SECTION 1-1'

16th Nov 2022

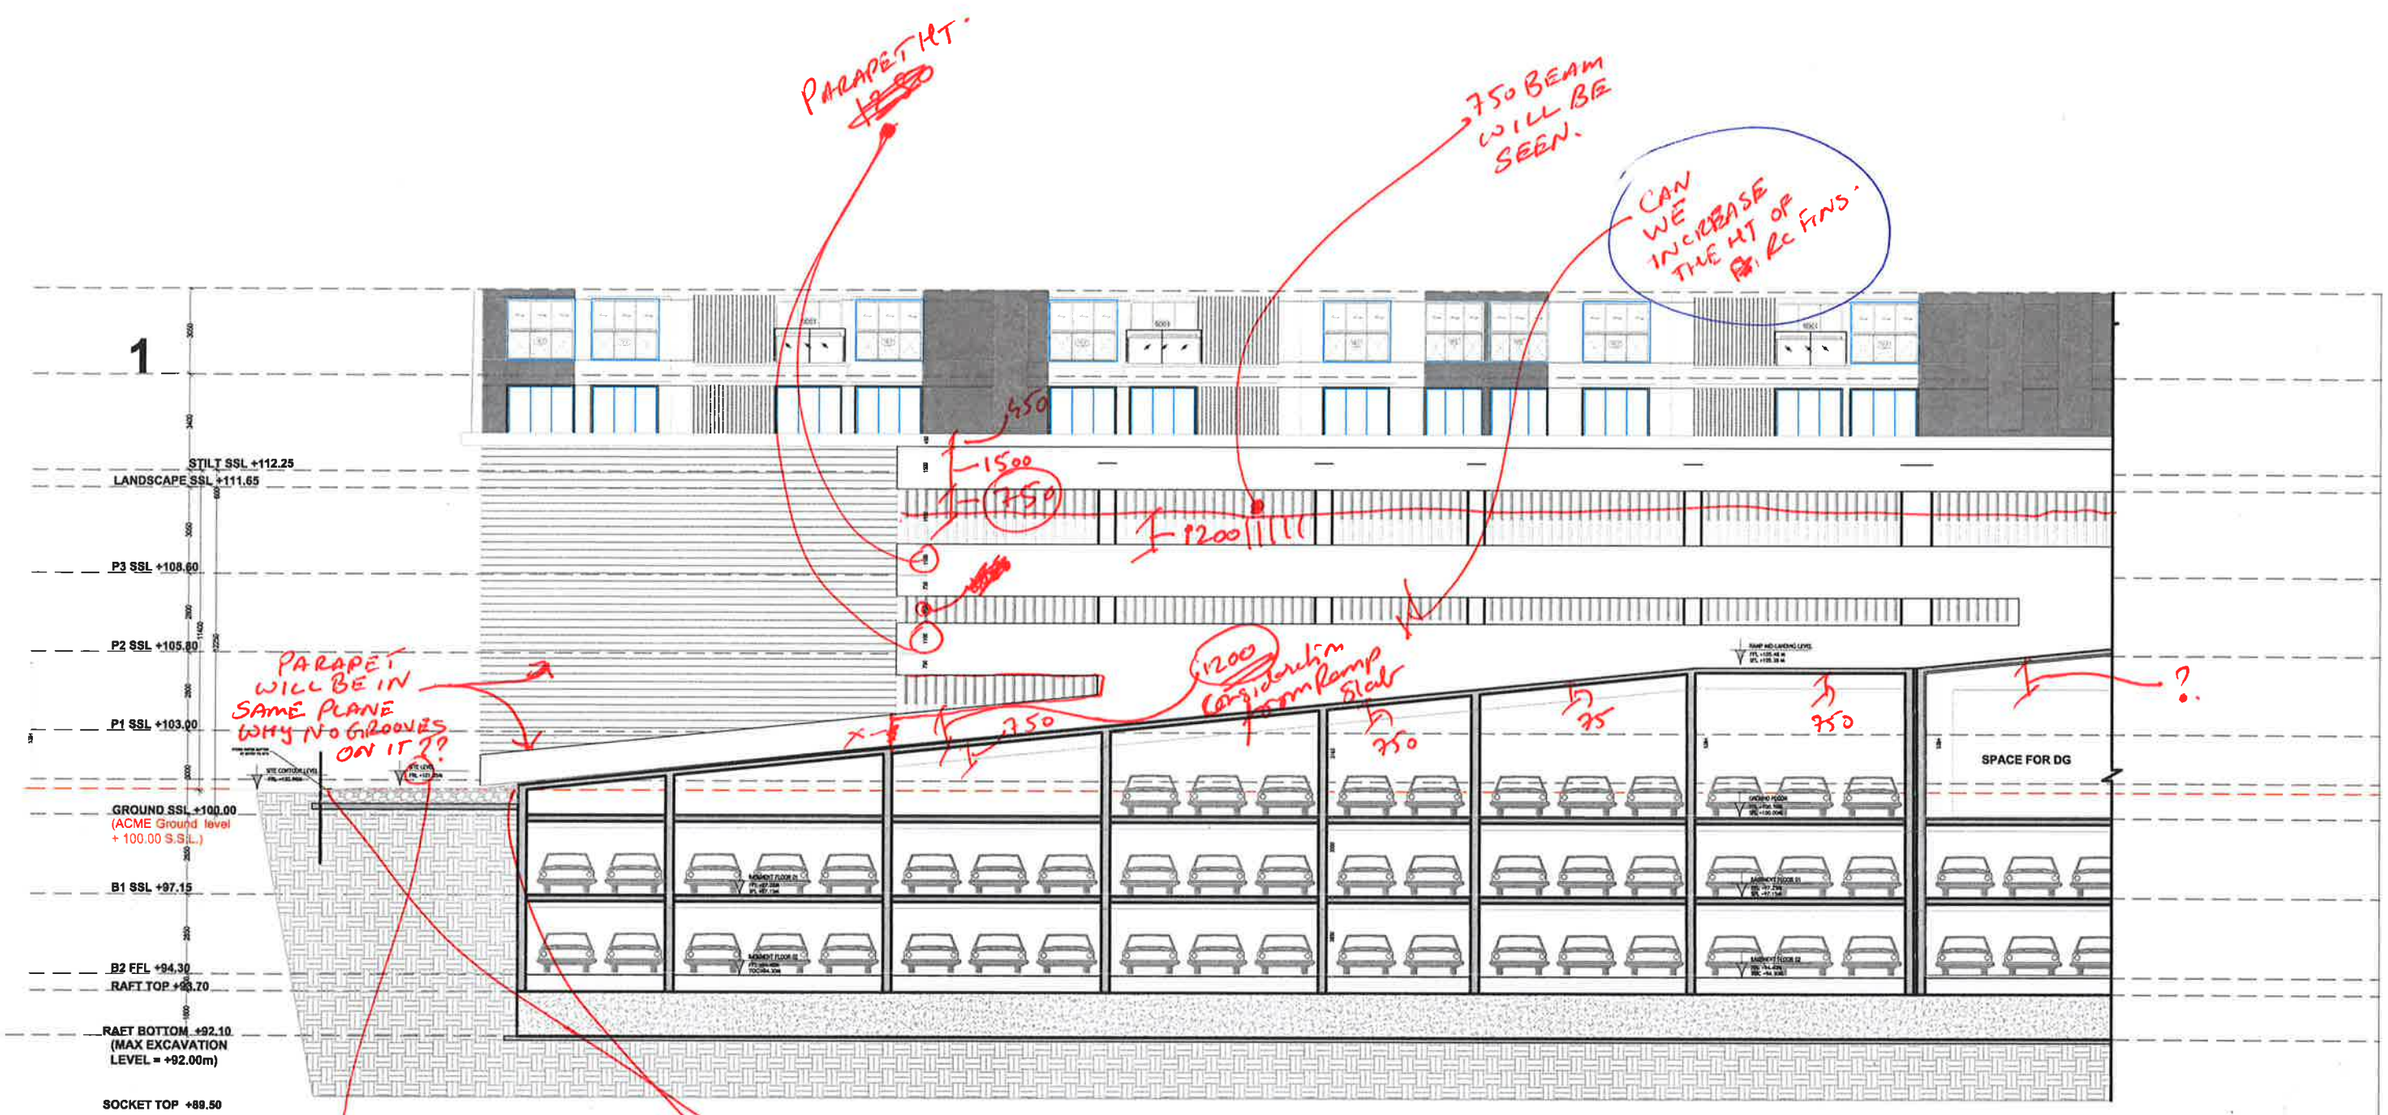
Will look very small in elevation, also doesn't match with section 1.

Doesn't match with section 1

Basis for starting point??

• Struc. Beam depth will be 925 as slab thk is 225

• Arch dwg correct ✓

Step up in retaining wall section.

SECTION 33'

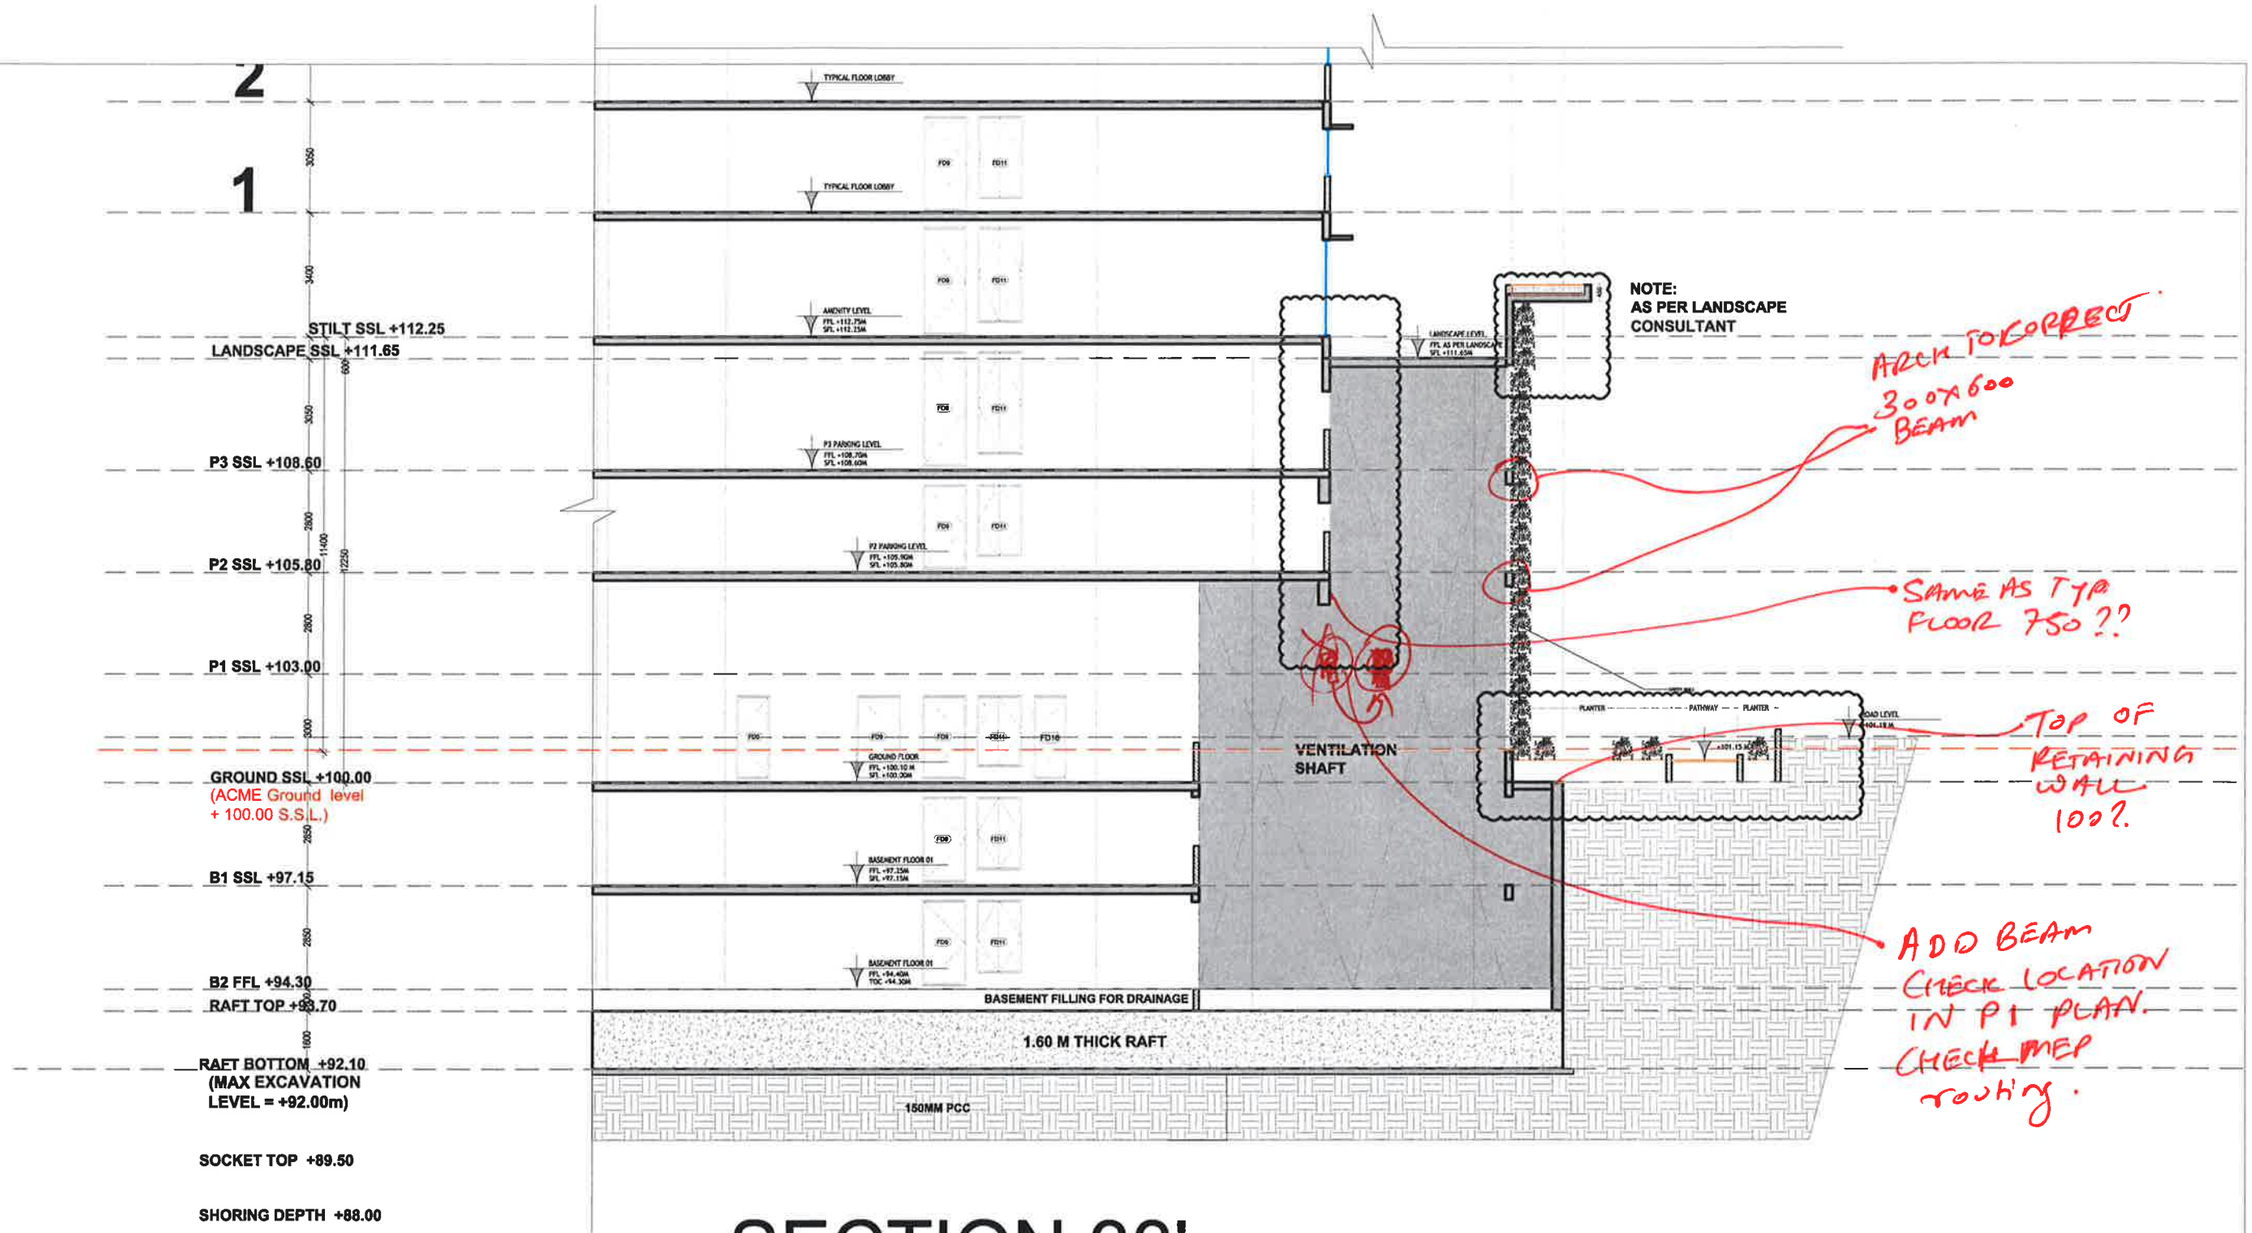
Top of retaining wall thk of wall above ground.

Check retaining wall profile in Gr. plans. Basement also (see struct plan)

Try to keep below 101. level for finishing tolerance

Struc. to check

SECTION 88

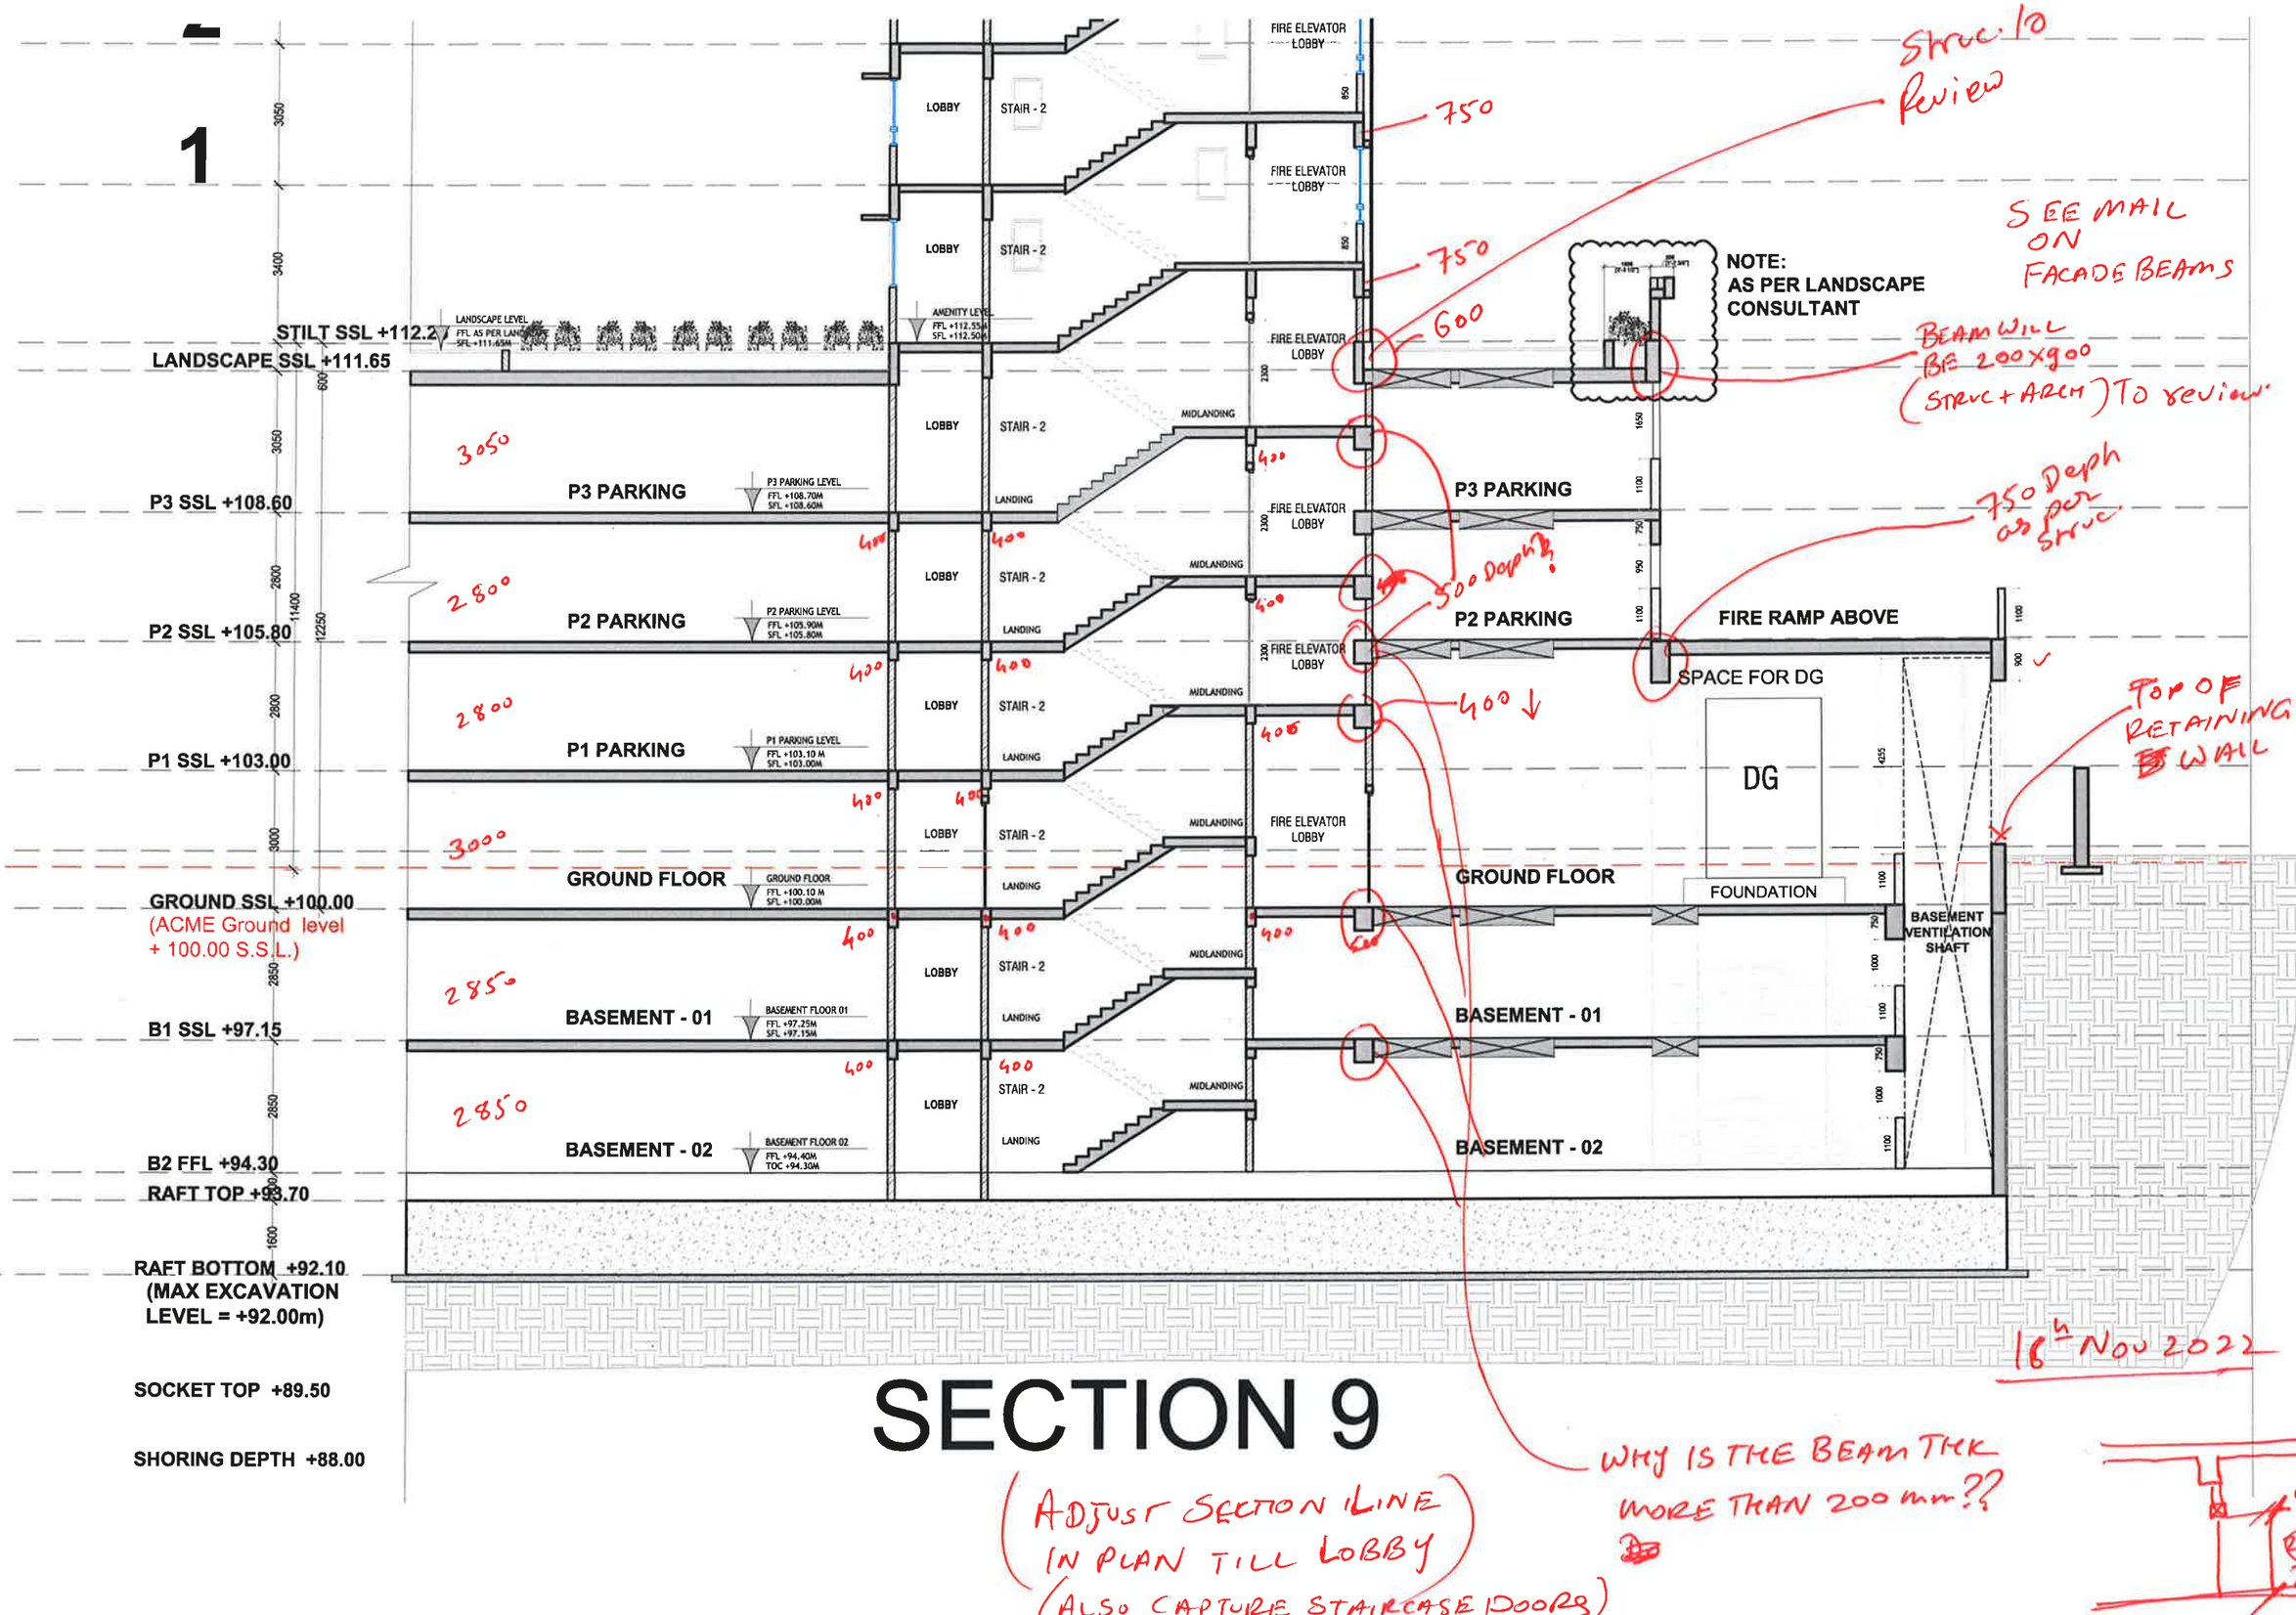
1
STILT SSL +112.2
LANDSCAPE SSL +111.65
P3 SSL +108.60
P2 SSL +105.80
P1 SSL +103.00
GROUND SSL +100.00
(ACME Ground level
+ 100.00 S.S.L.)
B1 SSL +97.15
B2 FFL +94.30
RAFT TOP +93.70
RAFT BOTTOM +92.10
(MAX EXCAVATION
LEVEL = +92.00m)
SOCKET TOP +89.50
SHORING DEPTH +88.00
LANDSCAPE LEVEL
AMENITY LEVEL
P3 PARKING LEVEL
P2 PARKING LEVEL
P1 PARKING LEVEL
GROUND FLOOR
BASEMENT FLOOR 01
BASEMENT FLOOR 02
LOBBY
STAIR - 2
LANDING
MIDLANDING
FIRE ELEVATOR
LOBBY
P3 PARKING
P2 PARKING
P1 PARKING
GROUND FLOOR
BASEMENT - 01
BASEMENT - 02
FIRE RAMP ABOVE
SPACE FOR DG
DG
FOUNDATION
BASEMENT
VENTILATION
SHAFT
NOTE:
AS PER LANDSCAPE
CONSULTANT
3050
3400
600
2800
11400
12250
2850
3000
1600
3050
2800
2800
2850
2850
3000
1650
1100
750
950
1100
1100
900
1100
1100
750
1000
1100
750
1000
1100
4255
2300
850
850
2300
2300
2300
Struc to review
SEE MAIL ON FACADE BEAMS
BEAM WILL BE 200x900 (STRUC + ARCH) TO review.
750 Depth as per struc
500 Depth?
TOP OF RETAINING WALL
WHY IS THE BEAM THK MORE THAN 200 mm??

(ADJUST SECTION LINE IN PLAN TILL LOBBY (ALSO CAPTURE STAIRCASE DOORS)
CHECK
16th Nov 2022
